| Flight Procedure Tracking Form | | Action: FLIGHT CHECK | Task Type: CVFP | Date Open: 11/22/2017 | Task #: 2016120928982209001 | Request #: 20161209289822 |
| Procedure: EVAL TIPP TOE VISUAL RWY 28L/R KSFO CVFP 2018 AMDT 2 | | | Airport ID: KSFO | Airport: SAN FRANCISCO INTL | | Reimbursable #: NO |

TIPP TOE VISUAL RWY 28L/R

**DEPARTMENT OF TRANSPORTATION
FEDERAL AVIATION ADMINISTRATION
CATEGORICAL EXCLUSION DECLARATION**

TIPP TOE VISUAL RWY 28L/R

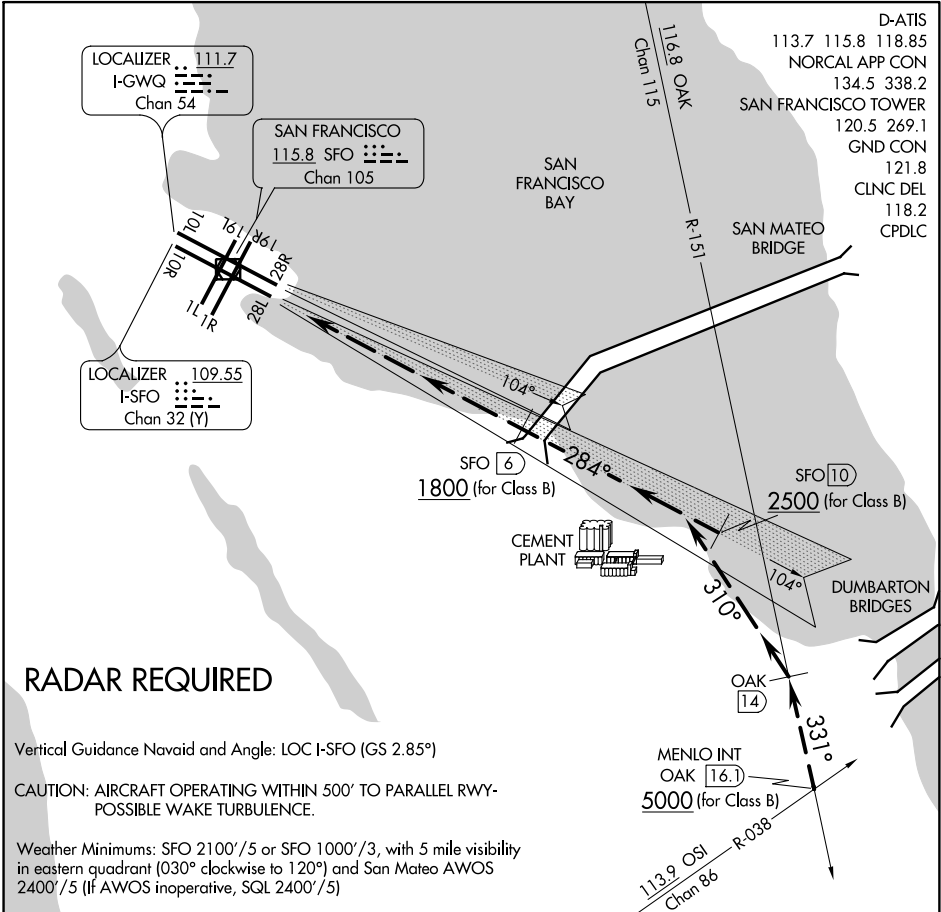
| <p>2/2/2018: THIS IS A CORRECTED COPY OF THE FORM APPROVED ON 1/12/2018:</p> <ol style="list-style-type: none"> 1. CHANGED VERTICAL GUIDANCE NAVAID AND ANGLE ON PROCEDURE PAGE FROM I-SFO LOCALIZER (GS 3.00) TO (2.85). 2. COMBINED INFORMATION IN THE SUPPLEMENTARY SECTION INTO ONE NOTE. 3. ADDED CHART I-GWQ LOCALIZER TO THE SUPPLEMENTARY SECTION NOTE. <p>2/7/2018: THIS IS A CORRECTED COPY OF THE FORM APPROVED ON 1/12/2018.</p> <ol style="list-style-type: none"> 1. CHANGED FIX NAME FROM SHIRA TO CHERA. <p>CONTACT JACOB POWERS 405.954.8702</p> | | | | | | |

Vertical Guidance Navaid and Angle: LOC I-SFO (GS 2.85°)
